**Re: REQUEST FOR DETERMINATION OF SIDEWALK STANDARD
Tract C, Cottonwood Pointe Subdivision
Minor Subdivision Preliminary and Final Plat Review
Regarding Sidewalk Placement Along Eagle Ranch Drive
DRB Project # 2019-002874**

**Re: Justification for Waiver of 5'-6' Buffer on Arterial Streets
Tract C, Cottonwood Pointe Subdivision, DRB Project # 2019-002874**

**Exhibit B
Existing Eagle Ranch
Road with
3' Buffer**

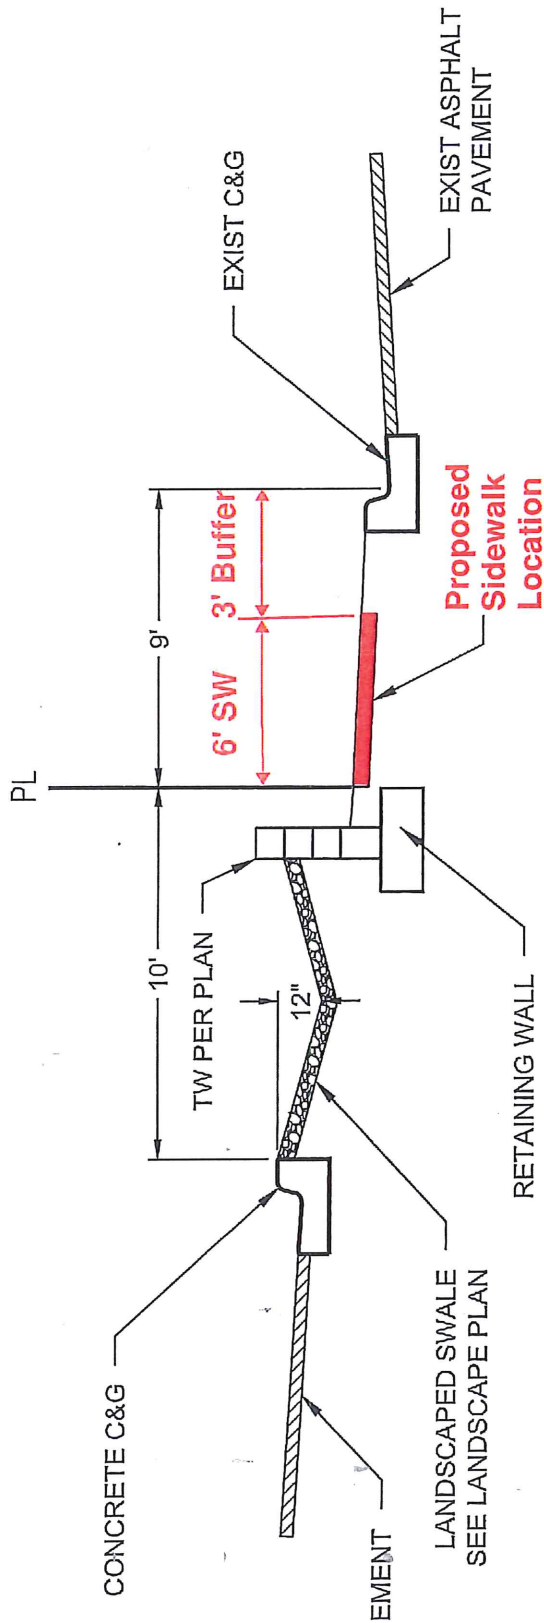
- 7) The proposed alternative is consistent with existing sidewalk placement on previously developed sites in this corridor. The adjacent apartment complex located to the north has sidewalk at the same location (see exhibit B). Therefore, the suggested location conforms to previous designs.
